Brisbane Central Business District Bicycle User Group CBD BUG

I refer to your letter dated 27 March 2019 in relation to our request for casual bicycle parking at the Royal Brisbane and Women's Hospital (RBWH) and The Prince Charles Hospital (TPCH).

Figure 2 - Bike parking but with poor passive surveillance

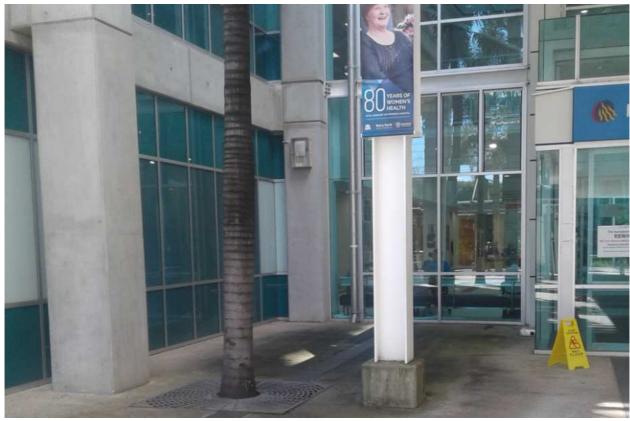
This location is tucked away in the campus and quite distant from the main entrance and has poor after hours passive surveillance (figure 2). This location is not listed on the Campus Map nor hospital website.
